Docket Number:	09-AFC-05C
Project Title:	Abengoa Mojave Compliance
TN #:	257843
Document Title:	Mojave Solar Project Response to Data Request Set 2
Description:	N/A
Filer:	Deric Wittenborn
Organization:	Ellison Schneider Harris & Donlan LLP
Submitter Role:	Applicant Representative
Submission Date:	7/19/2024 12:26:08 PM
Docketed Date:	7/19/2024

MSP Two New Permanent Evaporation Ponds-Data Request, Set 2- Responses

WATER RESOURCES

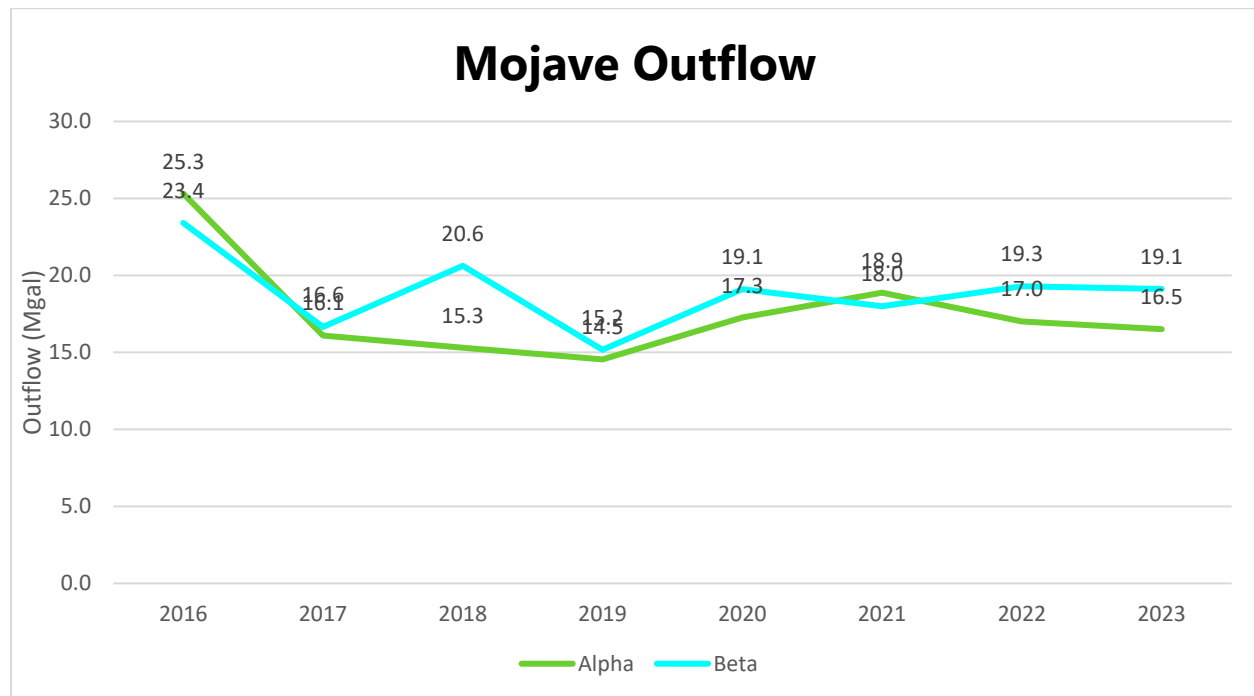
DR3. Provide data demonstrating that the CCRO system modification has not resulted in increased discharge to the evaporation ponds.

Response to DR3. This request presupposes that the CCRO system modification increased discharge to the evaporation ponds. MSP asserts that the data for outflow to the evaporation ponds (provided with MSP's responses to Data Request Set 1) does not show a pattern that confirms an increase in outflow to the evaporation ponds after CCRO operation.

MSP has further assessed the outflow data and provides the figure below to support the conclusion that outflow data is not correlated with CCRO operation. Because the outflow data since CCRO operation does not indicate a consistent trend at this time, MSP cannot conclude that changes in outflow are caused by the CCRO systems. In other words, there is insufficient evidence to infer that the CCRO system modification caused an increase in discharge to the evaporation ponds.

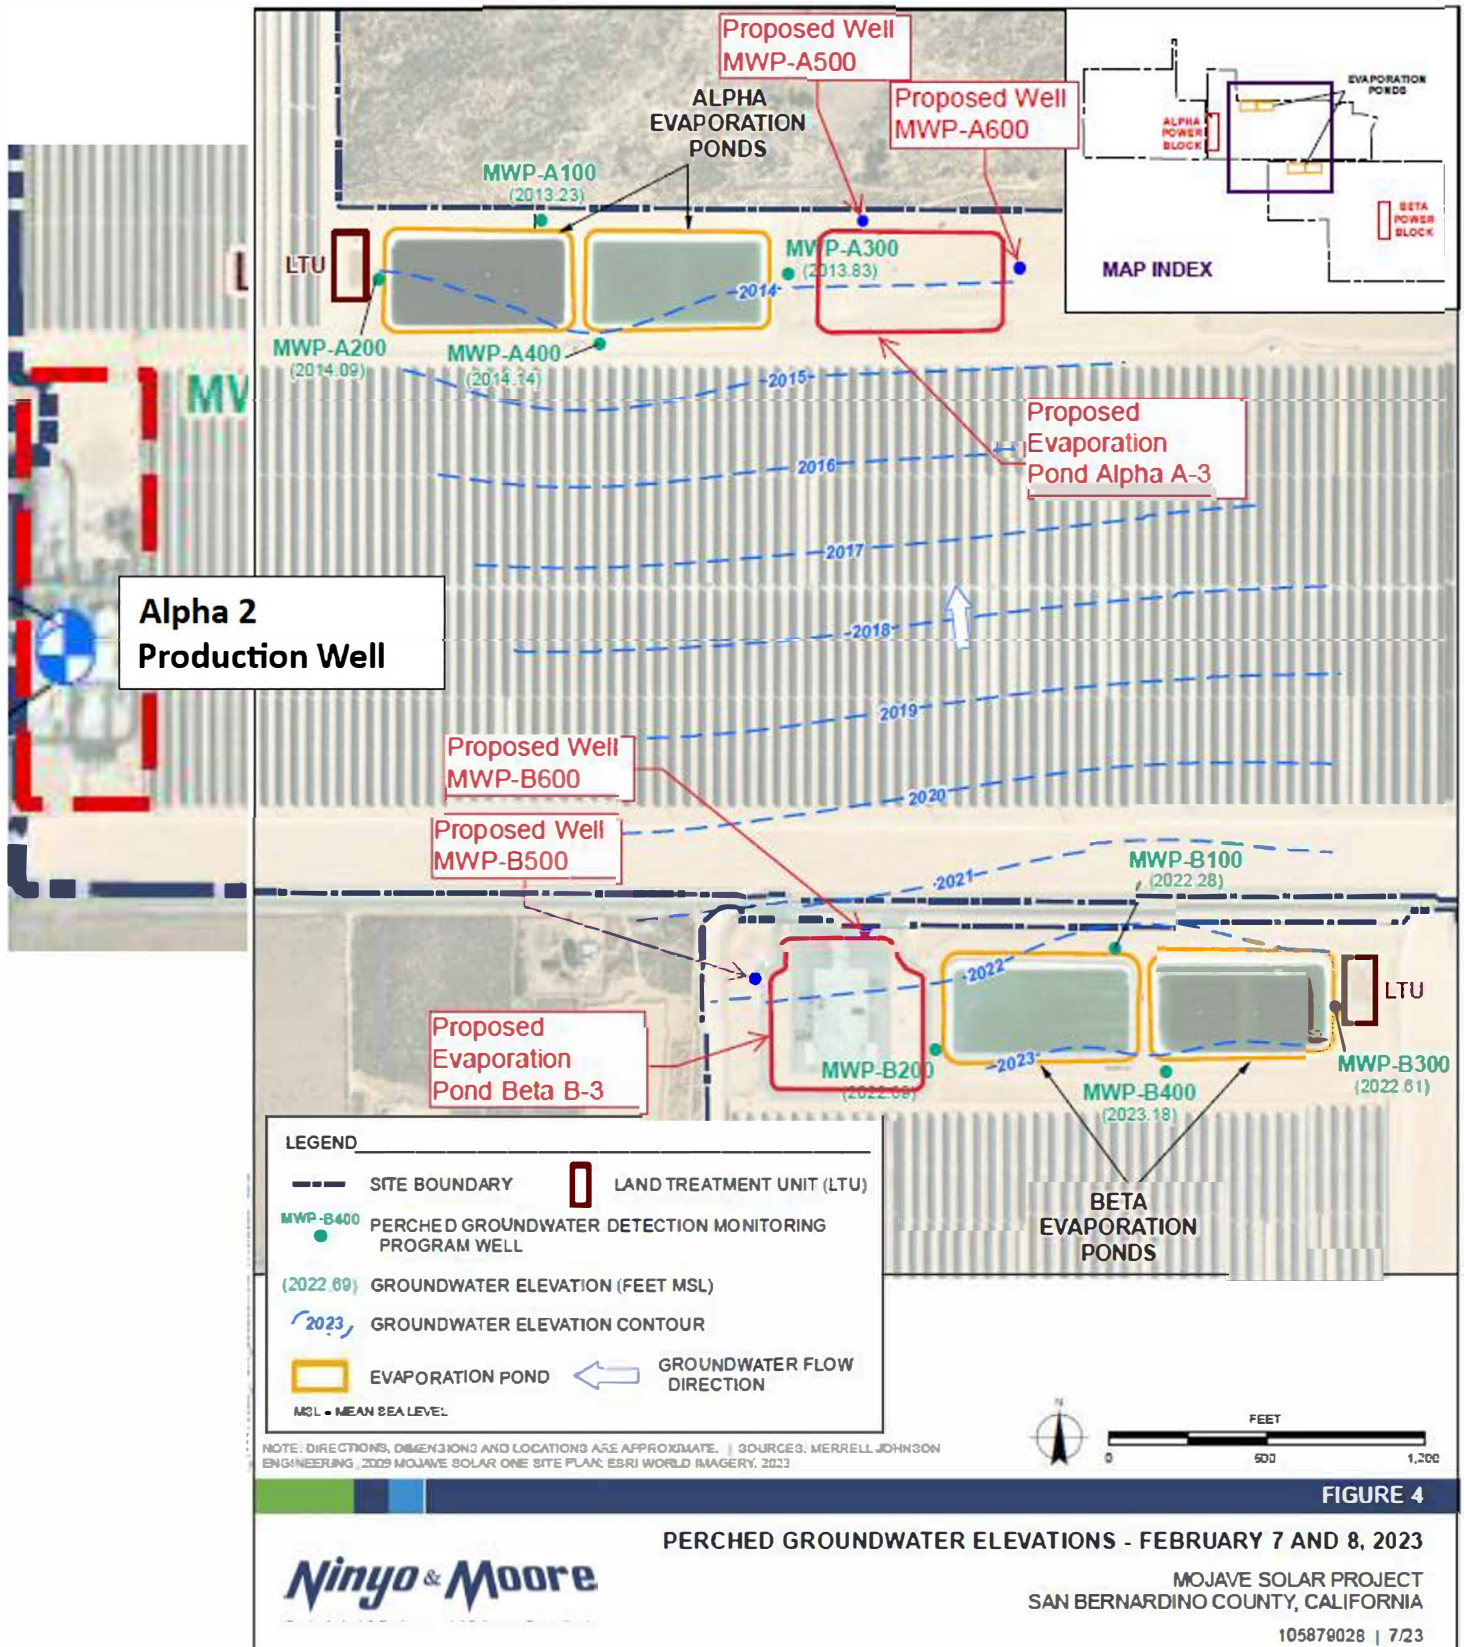
DR6. Are there monitoring wells installed downgradient of the existing evaporation ponds? Would new wells be installed downgradient of the new evaporation ponds?

Response to DR6. Please see the attached Perched Groundwater Elevations figure for the existing and proposed evaporation ponds and monitoring wells.

For the existing Alpha Evaporation ponds MWP-A-100 is downgradient, MWP-A200 and MWP-A300 are lateral to the groundwater gradient and MWP-A400 provides upgradient monitoring for background. The existing monitoring wells are generally equally spaced around the existing ponds. Hence, the original design of the monitoring well network is in all directions to account for any changes to the gradient due to potential influence of MSP water use from the wells.

Proposed monitoring wells for the new A-3 evaporation pond include MWP-A500 which is down gradient and MWP-A600 which is trans-gradient providing a lateral monitoring point.

For the existing Beta Evaporation Ponds, the existing monitoring wells are generally located similar to the layout for the Alpha Ponds. MWP-B100 is downgradient of the existing ponds, MWP-B200 and MWP-B300 are located lateral to groundwater flow and MWP-B400 is located upgradient of the existing ponds. The proposed new Beta Evaporation Pond (B-3 pond) will be located west of the existing ponds. Two additional monitoring wells are proposed, and both are downgradient to the proposed pond.
